## Modify the text per the proposed baseline:

### 33.2.8.4.1 PSE PI pair-to-pair resistance and current unbalance

Figure 33–40—PD PI pair-to-pair current unbalance test ~~model~~ **setup**

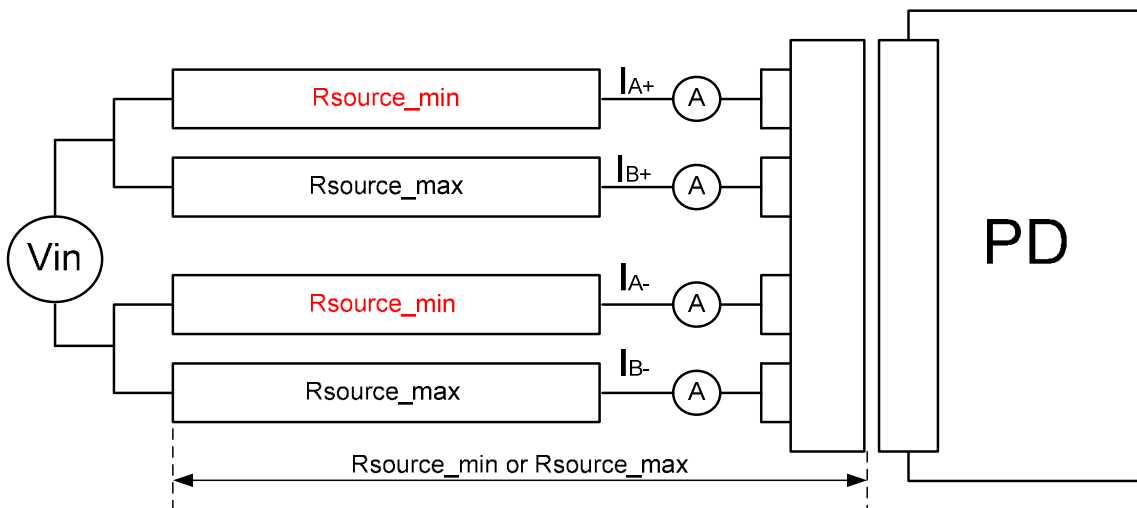
NOTE 1—Rsource includes test ~~model~~ **setup**-plug resistance Rcon. The maximum recommended Rcon value is 0.02  $\Omega$  however it is test setup implementation specific choice how to meet Rsource\_min and Rsource\_max.

**Figure 33A–4—PD resistance unbalance elements overview**

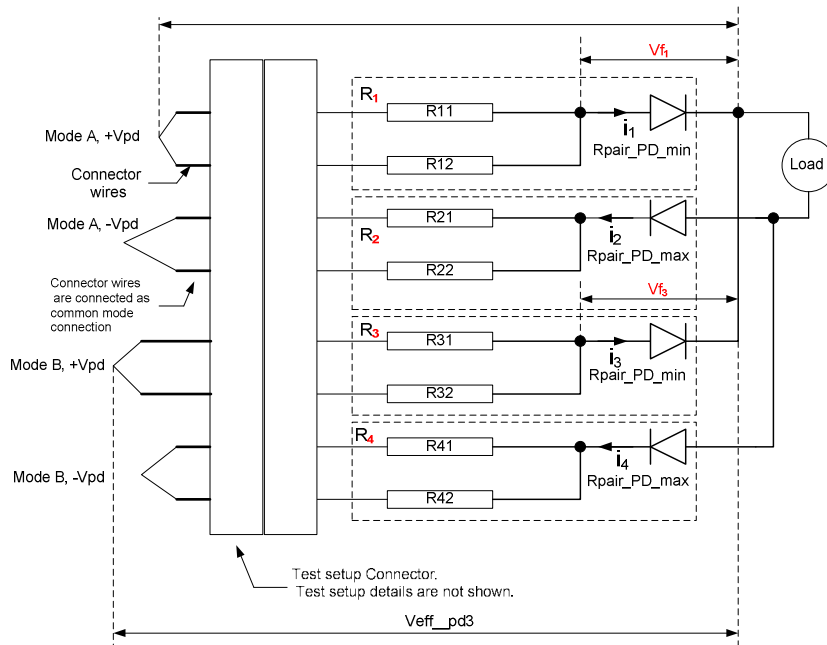
Update Figure 33A-4 as follows:

Positive pairs:

$$R_1 = R_{Pair\_PD\_min} = V_{eff\_pd1} / i_1$$

$$R_3 = R_{Pair\_PD\_max} = V_{eff\_pd3} / i_3$$

Negative pairs:

$$R_2 = R_{Pair\_PD\_min} = V_{eff\_pd2} / i_2$$

$$R_4 = R_{Pair\_PD\_max} = V_{eff\_pd4} / i_4$$
